Urgent Field Safety Notice
K310 & K320 TRAM, K660 E-Pacer
Device Modification

Rifton Equipment in conjunction with Glencar Medical their distributor in Ireland is voluntarily recalling the body support buckle from the Rifton TRAM and E-Pacer. The TRAM and the E-Pacer are transfer and mobility devices that can be used for seated transfers or as a support for standing or ambulation. The body support buckle helps to secure the client in the body support system. Rifton Equipment has received complaints of buckles failing to latch securely, presenting a risk of falling. **Serious injuries and/or deaths could occur due to the failure mode associated with this recall.**

The Body Support Buckle

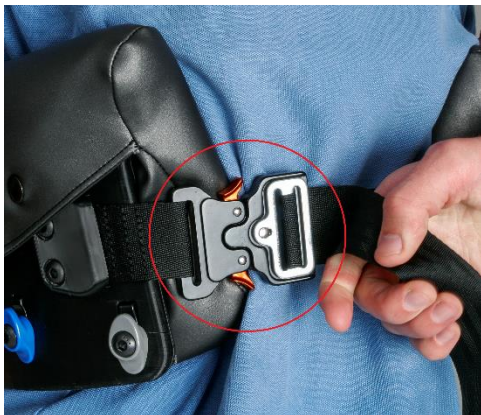
A design change within the buckle may lead to the buckle's internal springs breaking over time, making the buckle more difficult to securely latch, which could result in a sudden release during transfer.

1. **Please discontinue use of your TRAM or E-Pacer immediately until the buckle is replaced.** We will contact you in the coming days to arrange the on-site replacement of the affected buckle.
2. Please pass this field safety notice on to all those within your organization who need to be aware of it.

- A replacement buckle and strap assembly

A service technician from Glencar Medical will perform the replacement and will need to remove and discard the old strap, buckle and bolts, and install the new one with the new bolts.
